HAM-CR196-1.89

THIS PROJECT INCLUDES A WIDENED APPROACH OF KLEMME DR SOUTH OF DELHI PIKE AND TRAFFIC SIGNAL REBUILDS AT DELHI PIKE/KLEMME DR AND DELHI PIKE/DELHI TOWNE SQUARE.

CLOSED REVISIONS - 2/24/26
 -INVERT CHANGE FOR STORM CONDUIT, P-3
 -SIGNAL ITEM NUMBER CHANGE FOR PEDESTAL WITH TRANSFORMER BASE

TITLE SHEET

STORM SEWER SCHEMATIC PLAN

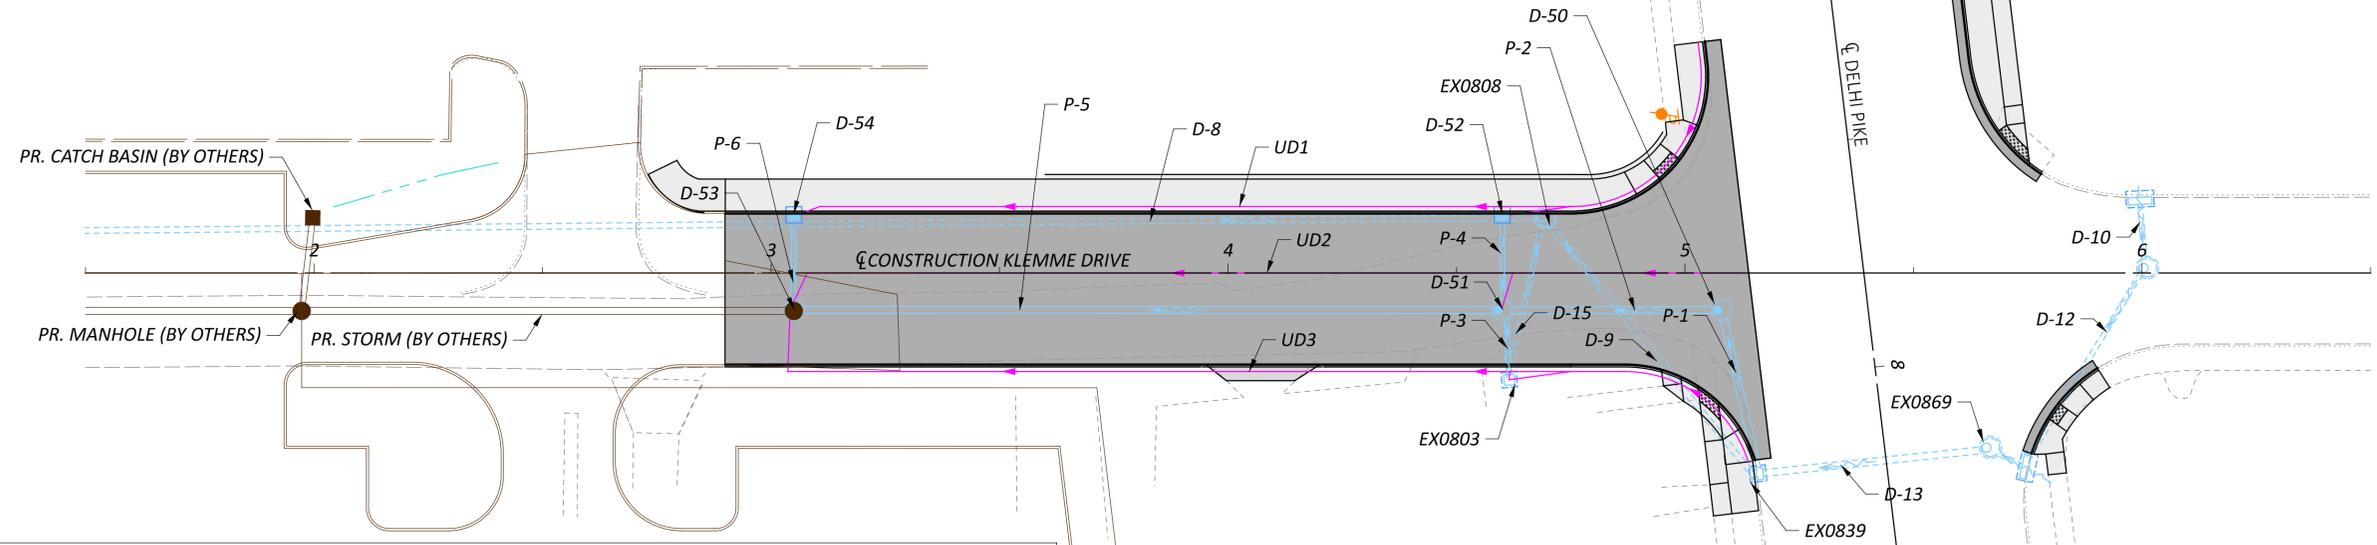
P-3 PIPE INVERT CHANGE

P-3 PIPE INVERT CHANGE

REFERENCE	LENGTH (FT)	SIZE (IN)	TYPE	SLOPE	START STRUCTURE REFERENCE	START INVERT ELEV.	STOP STRUCTURE REFERENCE	STOP INVERT ELEV.	EXISTING DISPOSITION
D-13	50	18	EX.	0.52	EX0869	885.60	EX0839	885.34	EX. DO NOT DISTURB
P-1	34	18	TYPE B	7.44	EX0839	885.00	D-50	882.50	
P-2	44	18	TYPE B	1.64	D-50	881.00	D-51	880.28	
P-3	13	12	TYPE B	10.89	EX0803	881.15	D-51	879.78	
P-4	18	12	TYPE B	9.97	D-52	881.53	D-51	879.78	
P-5	151	18	TYPE B	5.38	D-51	879.28	D-53	871.15	
P-6	18	12	TYPE B	3.81	D-54	870.65	D-53	869.98	
D-9	70	15	EX.	7.27	EX0839	884.09	EX0808	878.98	TO BE REMOVED
D-15	33	12	EX.	6.48	EX0803	881.15	EX0808	878.98	TO BE REMOVED
D-8	188	15	EX.	4.39	EX0808	878.98	D-17	859.76	TO BE REMOVED

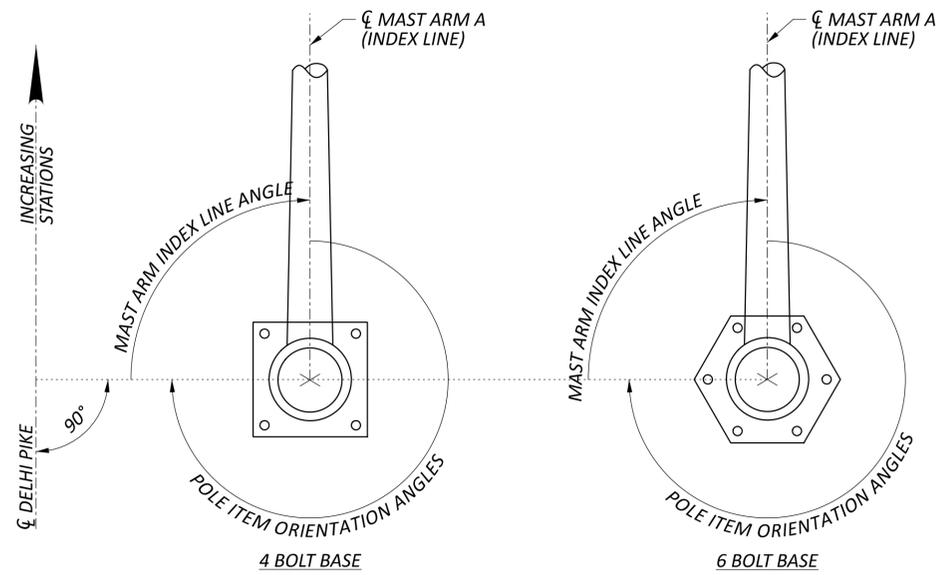
SIGNAL ITEM NUMBER CHANGE

HEIGHT CHANGE DUE TO ITEM NUMBER CHANGE

884.80				12		20	40	37	37	33	26	16	-	-	-	-	90	-	-	-	-	-	-	-
PS-1	4+59.9	38.9' LT	-	884.23	TC-83.20	-	-	10.7	-	-	-	-	-	-	-	-	-	-	0	-	0	0	-	-	-	-	-
PS-2	5+11.8	34.1' LT	-	884.86	TC-83.20	-	-	10.7	-	-	-	-	-	-	-	-	-	-	0	-	90/180	90/180	-	-	-	-	-
PS-3	4+07.5	34.3' RT	-	883.16	TC-83.20	-	-	10.7	-	-	-	-	-	-	-	-	-	-	0	-	180	180	-	-	-	-	-
PS-4	5+11.9	34.4' RT	-	884.94	TC-83.20	-	-	10.7	-	-	-	-	-	-	-	-	-	-	0	-	180/270	180/270	-	-	-	-	-

MAST ARM TABLE

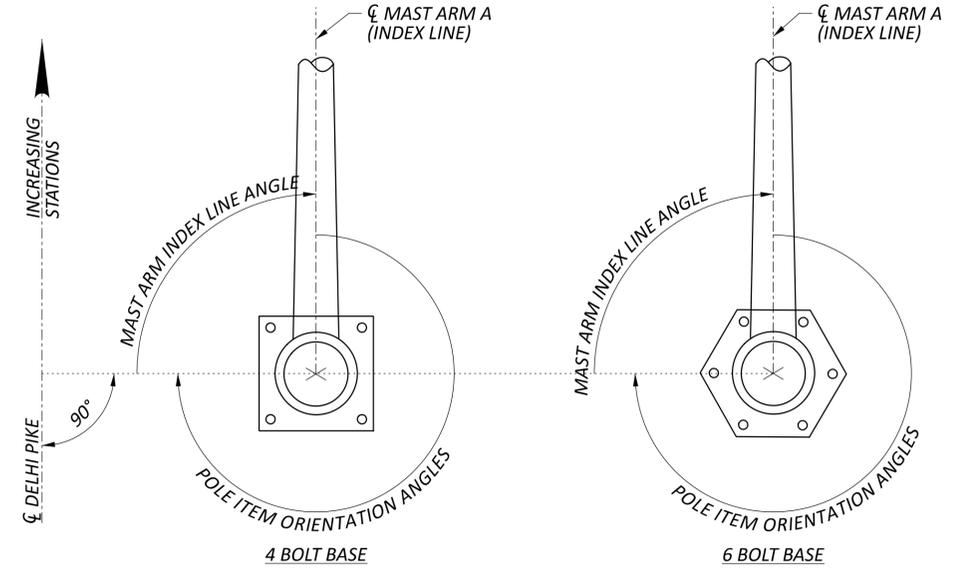
HEIGHT CHANGE DUE TO ITEM NUMBER CHANGE

PS-2	7+55.4	39.4' LT	-	888.22	TC-83.20	-	10.7	-	-	-	-	-	-	-	-	-	-	0	-	0	0	-	-	-	-	-	-
PS-3	7+42.6	38.9' RT	-	888.22	TC-83.20	-	10.7	-	-	-	-	-	-	-	-	-	-	0	-	0/90	0/90	-	-	-	-	-	-
